For: ROTARY CUTTING UNIT)

Serial No.: 08/883,685)

APPELLANT'S REPLY TO EXAMINER'S ANSWER

PETITION TO THE COMMISSIONER

Fig. 1

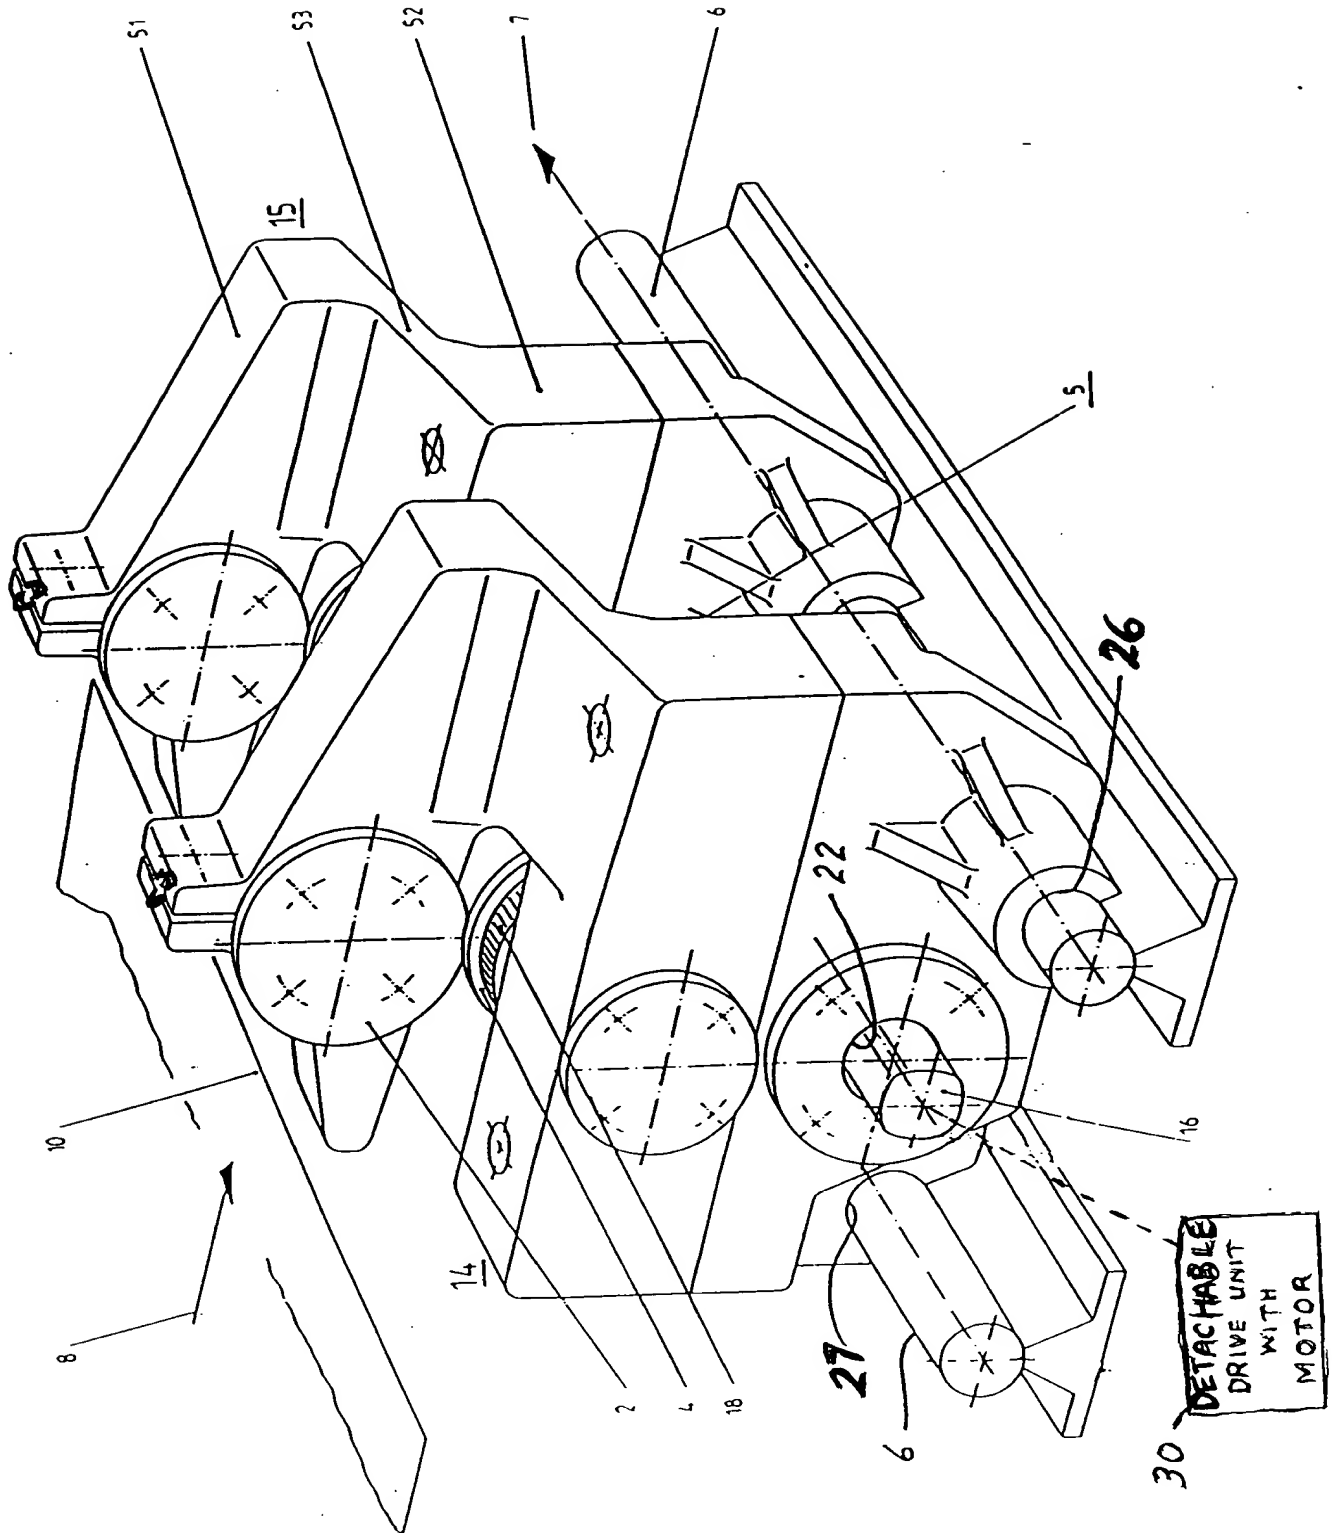
OBJECTION No. 2: "The drawings are objected to because references "26" and "27" should be interchanged to maintain consistency with the depiction in FIG. 1. Correction is required."

OBJECTION No. 3: "The drawings are objected to under 37 C.F.R. 1.83(a). The drawings must show every feature of the invention specified in the claims. Therefore the "means for releasably coupling" (claim 1, first occurrence) must be shown or the feature(s) cancelled from the claim(s). No new matter should be entered."

OBJECTION 2: Examiner objects to reference numerals "26" and "27" in Figure 1 which should be interchanged.

APPLICANT'S AMENDMENT: Figure 1 was amended by interchanging reference numerals "26" and "27".

ADDITIONAL AMENDMENT: Figure 1 was amended to include the slot for receiving pin wrench 25. (The slot for receiving pin wrench 25 was included in the original application in Fig. 4 as described below in paragraph 4.)

In response to paragraph 4 - 6 of the Office Action dated March 8, 2000, revised informal Figures 1 and 2 are enclosed which identify angle α and switch the references to components 26 and 27. The labeling for drive unit 30 has been changed by adding the word "detachable," and a slot for the pin wrench has been added to the cutter frame 51. The changes are marked in red. No new matter has been added to the drawings by this revision.
